## [MS-RDPBCGR]: Remote Desktop Protocol: Basic Connectivity and Graphics Remoting

Errata below are for Protocol Document Version <u>V52.0 - 2020/03/04</u>.

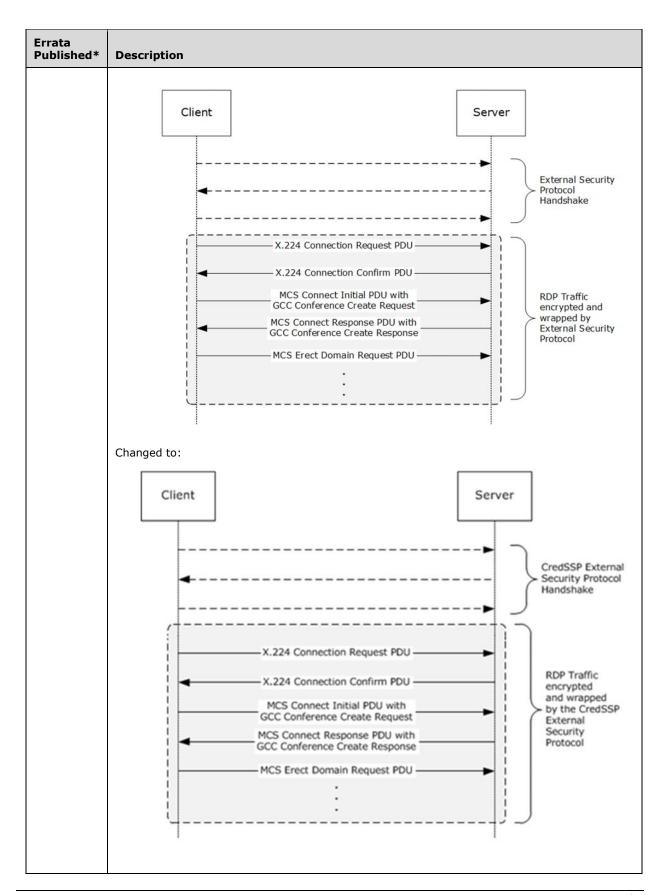
Errata Published*	Description	
	Changed from:	
	ERRINFO_CONTROLPDUSEQUENCE 0x000010CD	An out-of-sequence Slow-Path Non-Data PDU (section 2.2.8.1.1.1.1) has been received.
	Changed to:	
	ERRINFO_CONTROLPDUSEQUENCE 0x000010CD	An out-of-sequence Server Demand Active PDU (section 2.2.1.13.1), Client Confirm Active PDU (section 2.2.1.13.2), Server Deactivate All PDU (section 2.2.3.1) or Enhanced Security Server Redirection PDU (section 2.2.13.3.1) has been received.
	In Section 2.2.8.1.1.3.1.1, Slow-Path Input Event, revised definition for slowPathInputData.  Changed from: slowPathInputData (variable): TS_KEYBOARD_EVENT, TS_UNICODE_KEYBOARD_EVENT, TS_POINTER_EVENT, TS_POINTERX_EVENT, or TS_SYNC_EVENT. The actual contents of the input event specified by the messageType field (sections 2.2.8.1.1.3.1.1.1 through 2.2.8.1.1.3.1.1.6).	
2020/07/06	In Section 5.4.2.2, Direct Approach, rev Changed from:	ised the figure.
